MPC8360E Chip Errata

This document details all known silicon errata for the MPC8360. The following table provides a revision history for this document.

Figure 1. External Logic To Generate Gated Clock for the UCC

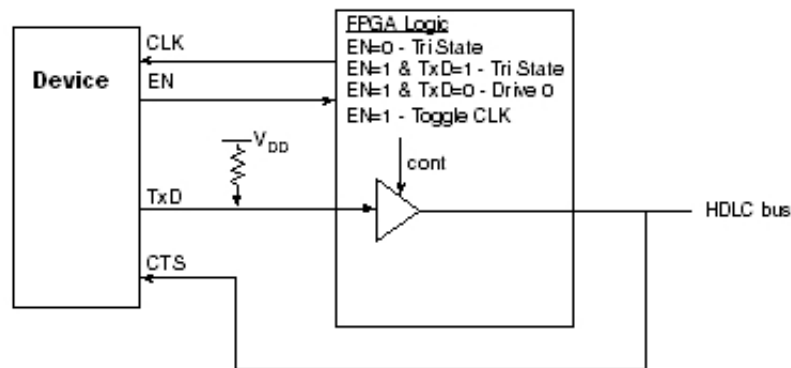
QE_HDLC1: UCC does not support HDLC bus mode through the TDM interface

The connectivity of \overline{CTS} from the NMSI input to the UCC in TSA mode is not enabled.

Impact: HDLC bus mode is not supported through the TDM interface.

Workaround: Program the UCC to NMSI mode and use external logic to generate the gated clock for the UCC at the assigned time slot, see Figure 1 below.

Figure 2. Example Schematic Drawing

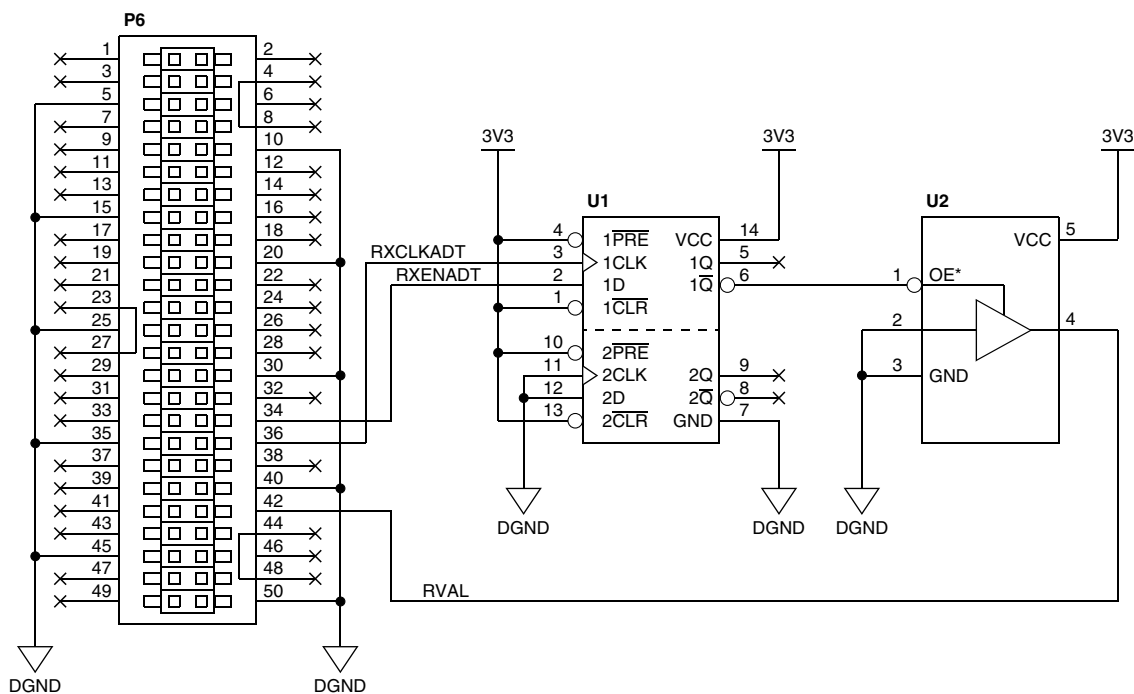
Impact: Corrupted data may be received in the receive buffer or the UPC peripheral may hang.

Workaround: The customer system should drive RVAL low within one POS interface clock after RENB negation (a high value). This can be achieved, for example, by connecting the inverted, one clock delayed sample of RENB (Master output) to the device RVAL pin (Master input), instead of the POS Slave RVAL output signal as illustrated in the following figure.
